October 17, 2011

RFP 11-13 SEASONAL ARTIFICIAL ICE SKATING RINK ADDENDUM #1

City Map

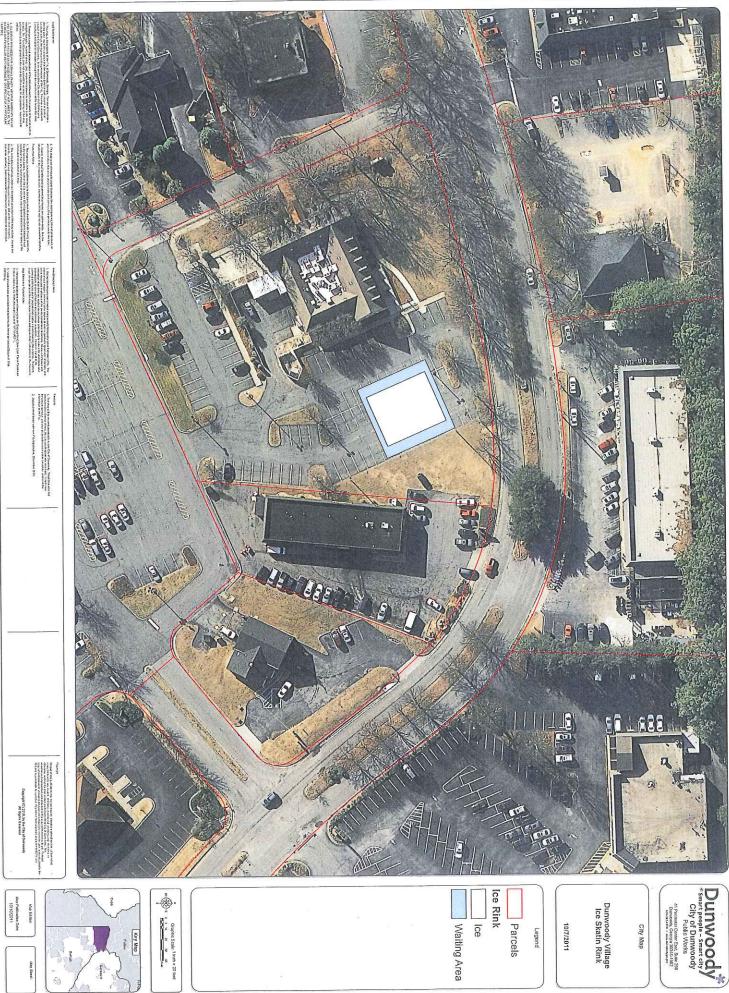
- A1 Renting for the season only.
- Q2 The panels will require a firm flat surface. Will you be providing the firm flat surface or do we have to provide a sub surface? If we are installing on a grass area, will we have to plant the grass after the removal of the system or the grass issue is not applicable to this project?

- **A2** Rink will be located in a parking lot (see map) in the 1300 block of Dunwoody Village Parkway. Contractor will have to provide any necessary sub surfacing.
